3rd meeting of GRRF Informal Working Group on Automatically Commanded Steering Function

Venue: AUDI Training Center – Airport Munich, Germany.
 Chairman: Mr. Christian Theis (D) and Mr. Hidenobu Kubota (J)
 Secretariat: Mr. Jochen Schaefer (CLEPA)
 Dates: 02.-03. September 2015
 Website: <https://www2.unece.org/wiki/display/trans/ACSF+3rd+session>

6.2.2.13. Annex 7**6.2.2.14. FU1 (lane keeping test)**

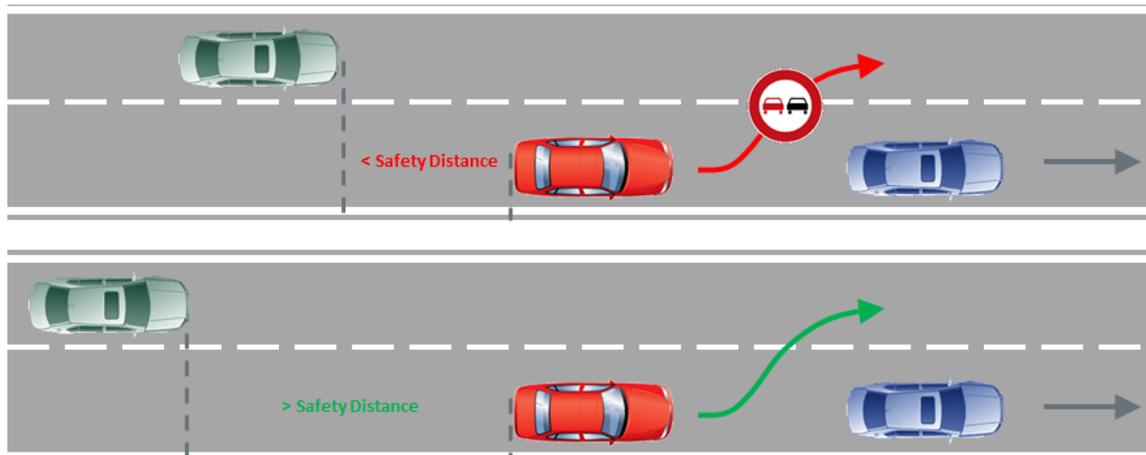
UK: system should also work without lead vehicle

D: main reason was to cover also Traffic Jam Assist (TJA) which may need a lead vehicle

EC: maybe different systems need different tests

UK: propose to concentrate first on CAT E

D: for CAT E no lead vehicle should be necessary

OICA: There may be CAT E systems only up to 40 km/h for traffic jam

D: In a traffic jam with max. 40 km/h a lane change makes no sense

Debate, whether the blue vehicle shall accelerate or change the lane, without result

Homework: OICA to define a new proposal for FU1-Test (CAT E)

6.2.2.15. FU 2 (new Lane change test)

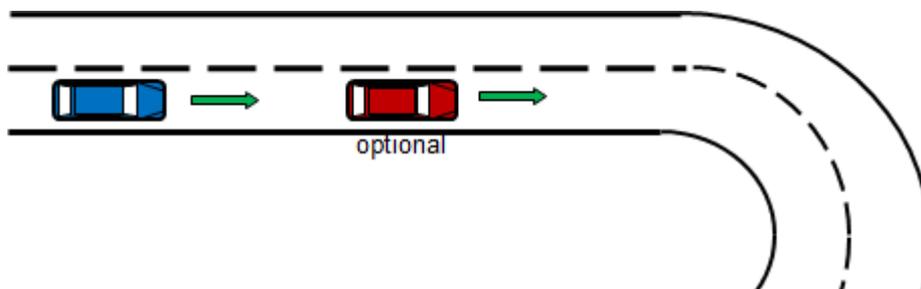
The current FU2-Test ([ACSF-03-09](#)) is very difficult to verify on a test track

CLEPA: proposes new Lane change test ([ACSF-03-14](#))

CPs confirm, that the test is in principle ok

Missing: - pass/fail criteria
- define safety distance requirements

Homework: CLEPA to complete the missing points

6.2.2.16. FU 2 (Lane change test with obscured vehicle)

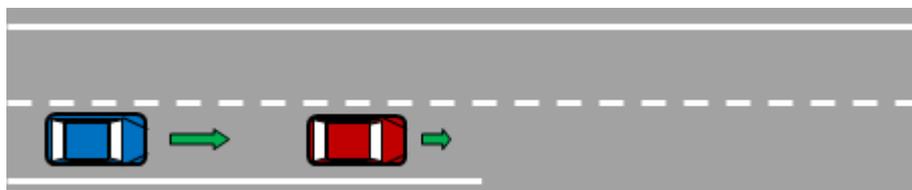
UK: a test, maybe by simulation, would be necessary to test the system, if a fast vehicle is coming from behind

CLEPA: explained document ACSF-03-05 where the physical parameters/values can be calculated. Even the sensor position, vehicle width etc. could be modified if sheet is unprotected by the password (“test”)

UK: the test should ensure that the vehicle can detect a narrow target approaching from behind before commencing a lane change manoeuvre

Homework: OICA/CLEPA to propose a test

6.2.2.17. TR 1 (tight curve: ay beyond system boundaries)

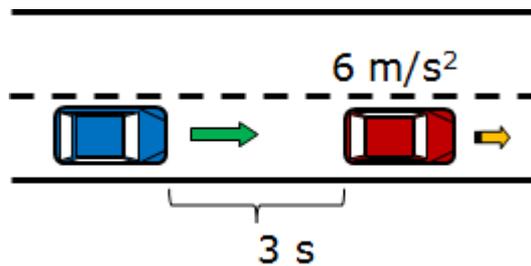
CLEPA: as a CAT E system should only work on motorways, it might be difficult for the technical Service to find an appropriate test track

OICA: sees no problem to run the test also on a “normal” test track

Homework: D + OICA + CLEPA to rework the test for CAT E only

6.2.2.18. TR 2 new (missing lane marking)

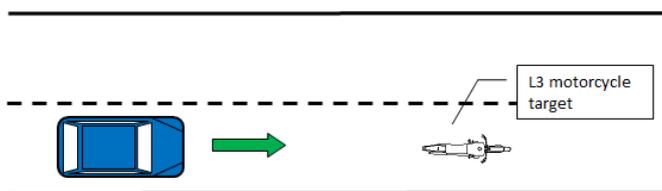
NL: propose that the driver will get the transition demand 5s prior the lane marking ends

OICA: with the current technic this is not possible

CPs confirm, that the test is in principle ok

Homework: D to rework the test
